Campaign No. 2021070026

SUBJECT: **Model 907 Sprinter, Model Year 2020  
Software Update**

<b>SM54.21-D-0229SG</b>	<b>Update software of control units (code: VS3MOGE20, acc. no.: 07 972 77)</b>	<b>12.12.2022</b>
-------------------------	--	-------------------

### Shown on model 906 with engine 642

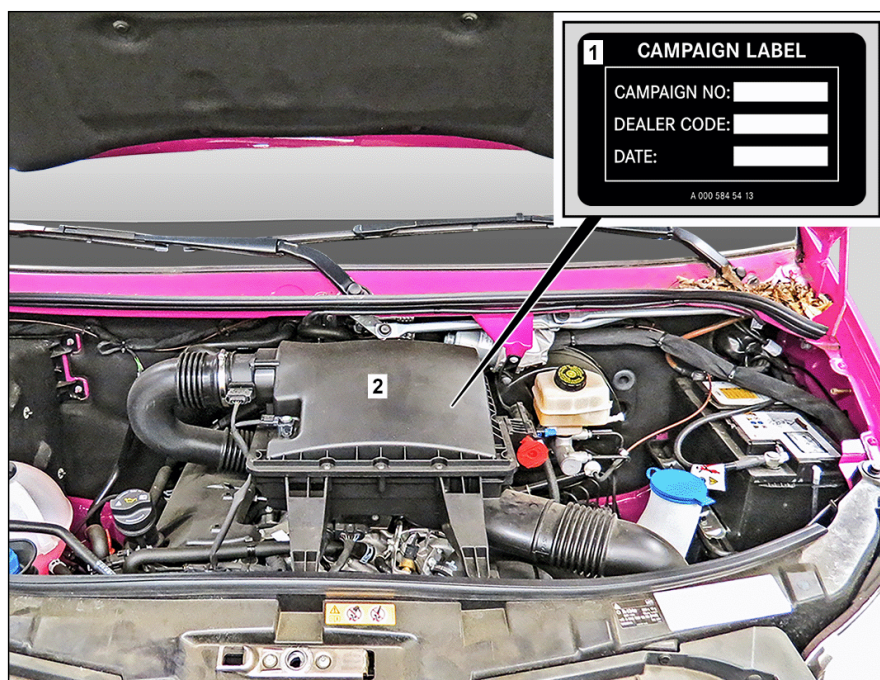
- 1 Campaign label
- 2 Air cleaner housing

8	Fill out certificate and hand over to customer.	<p>Only applies for vehicles in State of California.</p> <p> Apply number from campaign label (1).</p>
